## AEBS-12 – Industry Input

## **Car to Bicycle – Why Car2Bicycle AEBS is such a challenge**

**Car to Bicycle – Justification for a two step approach  
or generally increased lower avoidance speed**

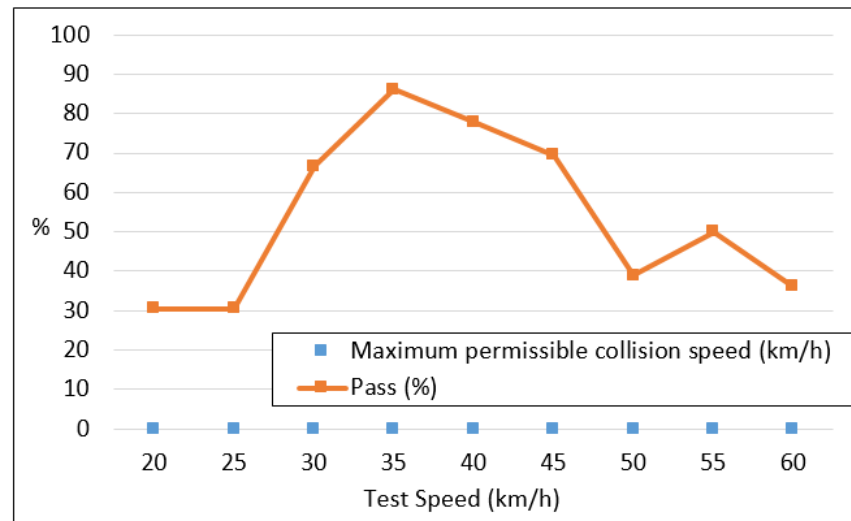
Two step approach

Collision avoidance in the speed range of 20-60km/h does not reflect the performance of today's AEB systems.

## Impact speed acc. to Industry proposal

### Maximum Impact Speed (km/h) for $M_1^*$ (Step 1)

Subject vehicle speed (km/h)	Maximum mass	Mass in running order
35	0	0
40	10	10
45	25	25
50	30	30
55	35	35
60	40	40

### Maximum Impact Speed (km/h) for $M_1^*$ (Step 2)

Subject vehicle speed (km/h)	Maximum mass	Mass in running order
25	0	0
30	0	0
35	0	0
38	0	0
40	10	10
45	25	25
50	30	30
55	35	35
60	40	40

Chart 1: Average Platform Longevity by Decade of Introduction and Vehicle Type

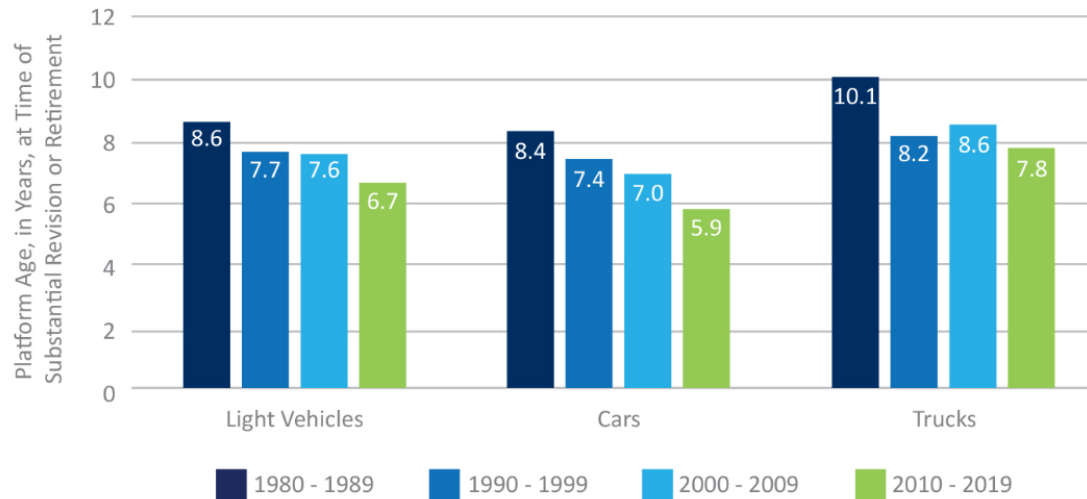
- ▶ If the average platform longevity is assumed to be 6.7 years, additionally a development time of 3-5 years has to be taken into account. Especially for small-scale series the platform longevity can be significantly longer.
- ▶ Even assuming average development and production periods the AT date for C2B in 07/2026 will affect vehicles whose development started around 2015.

## Automotive Product Life Cycle.

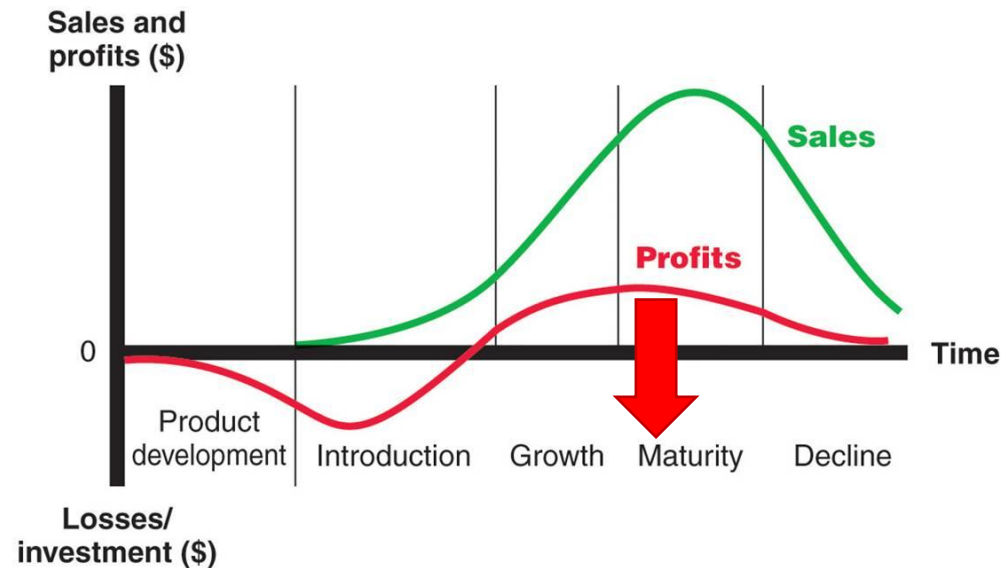
- ▶ Regulation changes in late stages of the product life cycle will necessitate unplanned investments and affect the profitability of the vehicle model.
- ▶ This can force an early end of production.

## Seeking Clarification that deactivation of the AEBS as a response to the ESC being unavailable is considered „automatic deactivation“

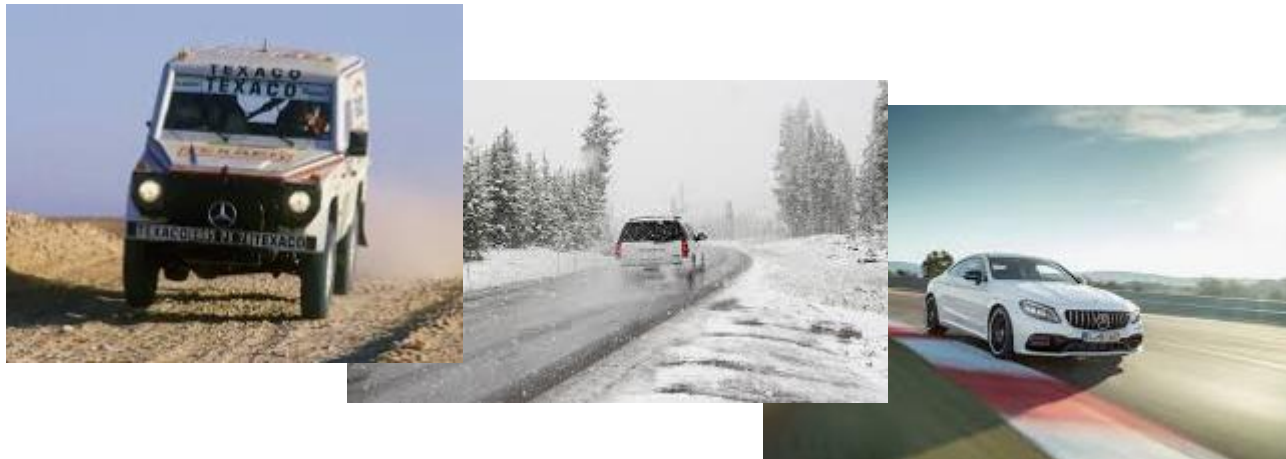
- In a lot of vehicles ESC cannot be fully deactivated, but only reduced to a very late/reduced intervention, which will likely not lead to a deactivation of the AEBS
- Some special vehicles provide, due to their operating environments, the possibility to fully deactivate the ESC
- Both, the deactivation of ESC as well as the automatic deactivation of the AEBS will be indicated to the driver

- Under certain circumstances, any ESC intervention, even a reduced one, can be unwanted by the driver.

- Under these circumstances, an AEB intervention could lead to unexpected vehicle behavior
